Application for Works Approval

Works Approval Number	W6163/2018/1
Applicant	Hanson Construction Materials Pty Ltd
ACN	009 679 734
File Number	DER2018/001178
Premises	Hanson Oldbury Sand Quarry Legal description - Lot 6 on Diagram 47557, Lot 300 on Diagram 75682 and Lot 301 of Diagram 75682 Banksia and Boomerang Roads, OLDBURY, WA 6121
Date of Report	6 October 2021
Status of Report	Final

Figure 2: Extractive footprint – Staged Screening operations, including plant location identified by yellow dots, labelled Phases 1 to 3.

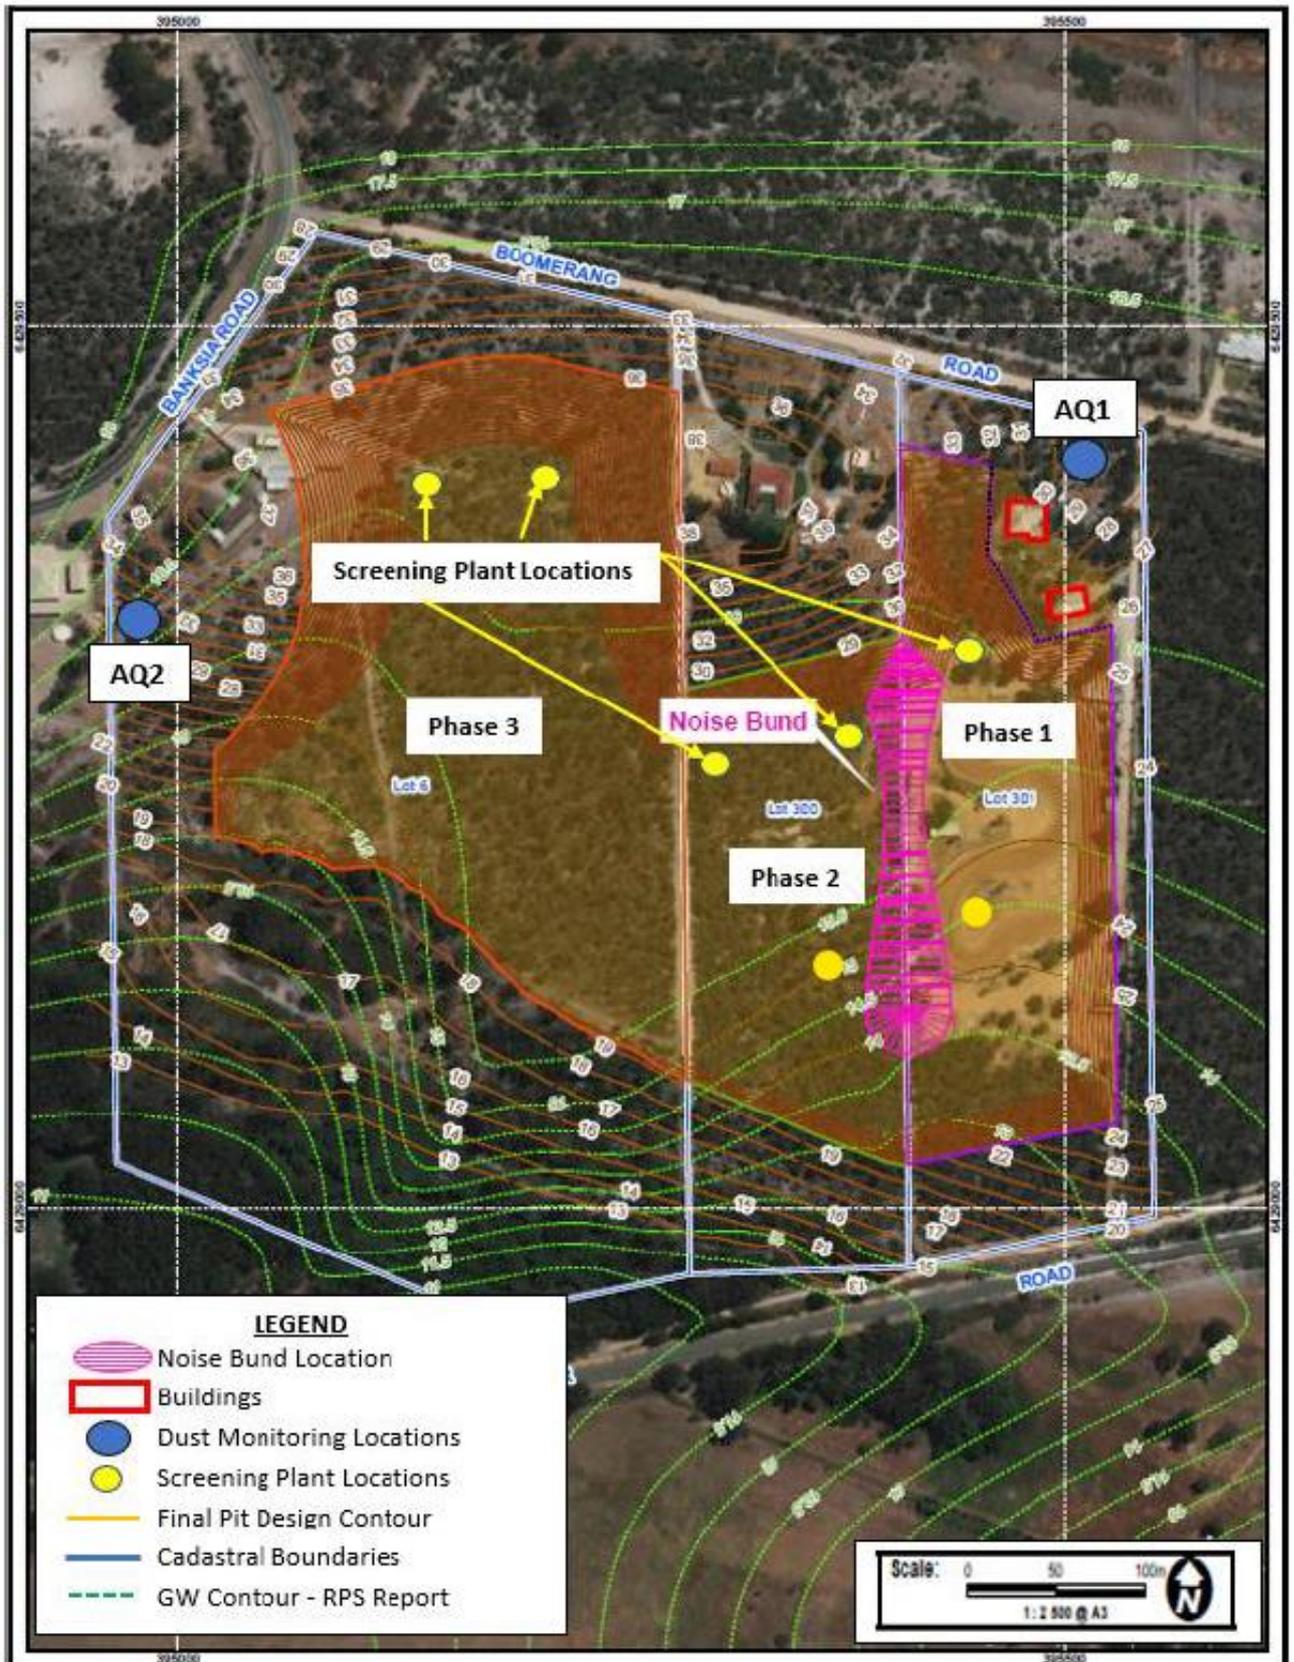
Figure 2 – screening plant location	<p>Condition 1c – we request an additional screening location be identified on the map for transparency (Figure 2 within the Draft WA & Decision Report). The initial screening location will be within the southernmost corner of Phase 1 as correctly identified within the decision report (Section 6.1.2). During the initial phase of the operations (Phase 1), the operations are close to the eastern face of the pit to provide a sufficient barrier effect to ensure compliance with the Regulations during the operating times of 7.00 a.m. to 5.00 p.m. Monday to Saturday (Excl Public Holidays). This has been modelled in the initial assessment for Rocla as per Figure 4.1 below.</p>	<p>DWER has sought technical advice regarding this request and agrees that this additional screening location can be added to Figure 2 in Schedule 1 of the works approval. Technical advice confirms that this location has been modelled and that noise emissions have been predicted to meet Noise Regulation assigned levels.</p>

Condition 6 – Table 2: Item 1 Infrastructure Location	Hanson propose an additional two screening plant locations as per the additional yellow dots in Phase 1 & 2 below – this will allow for material to be processed as close to the working face as possible (which will act as a noise & visual buffer) reducing potential generated dust, vehicle movements, vehicular noise and subsequent carbon emissions.	<p>DWER has sought technical advice regarding this request (A2046747) and agrees that this additional screening location can be added to Figure 2 in Schedule 1 of the works approval.</p> <p>Figure 2 has been replaced with a new map.</p>
Condition 6 – Table 2: Item 7, 3rd Dot Point (Bund Height)	Delete 3rd dot point as it conflicts with the two previous dot points, is incorrect and should be removed. The Noise bund consists of retaining the existing natural ridgeline which will have remnant vegetation on top.	3 rd dot point has been removed as this was mistakenly left in the draft after the second review.
